Work Order ID 85987

Item Name: Crosstube Turning Detail

DRAWING NO. D412-664-243	TITLE CROSSTUBE ASSEMBLY (412 HI AFT)	REV. E	DART AEROSPACE LTD ENGINEERING ORDER		D.E.O. NO. D412-664-243-E-1	SHEET NO. SHEET 1 OF 2	SCALE NTS
DRAWN	CHECKED <i>MP</i>	MFG. APPR. <i>E</i>	APPROVED <i>MP</i>		DE APPR. <i>MP</i>		
DATE 11.03.31	DATE 11/03/31	DATE 11.03.31	DATE 11/03/31		DATE 11.03.31

**D412-664-243
ASSEMBLY DETAIL**

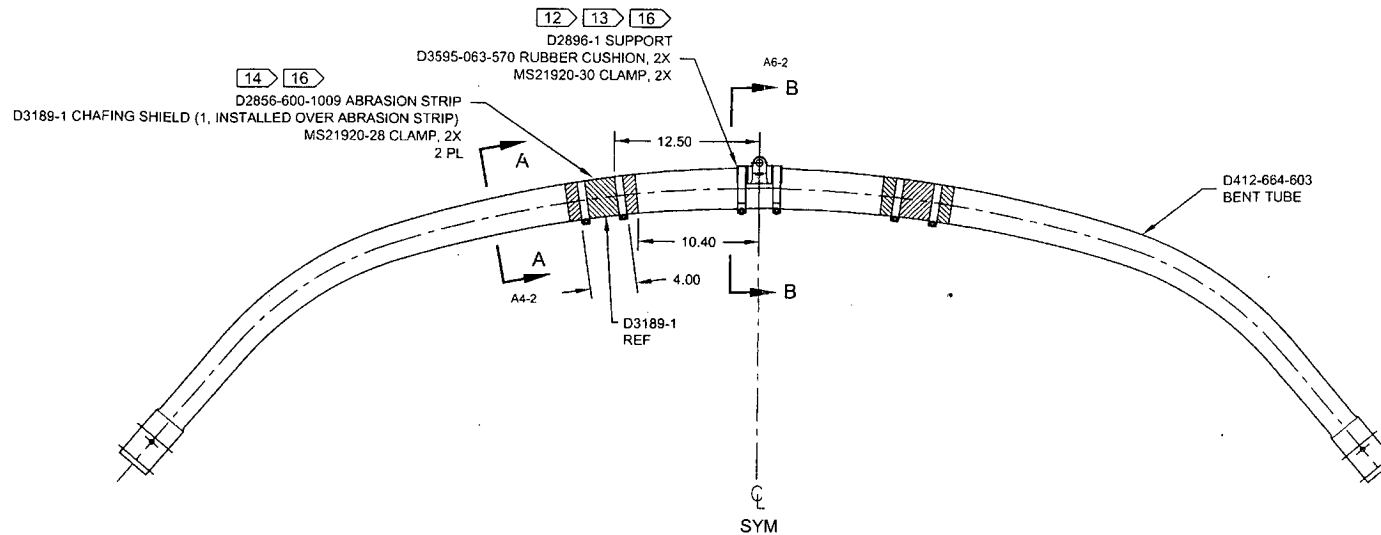
PURPOSE:

REMOVED ABRASION STRIP IN FAVOR OF A THIN LAYER OF PROSEAL 890.

NOTES 2 AND 14, SHEET 1 ARE AMENDED AS FOLLOWS:

IS:

D3189-1 CHAFING SHIELD (1, INSTALLED OVER PROSEAL 890)
MS21920-28 CLAMP, 2X
2 PL

WAS:

D2856-600-1009 ABRASION STRIP
D3189-1 CHAFING SHIELD (1, INSTALLED OVER ABRASION STRIP)
MS21920-28 CLAMP, 2X
2 PL

MASK AREA PRIOR TO PAINTING AND
APPLY CLEAR COAT AFTER PAINTING
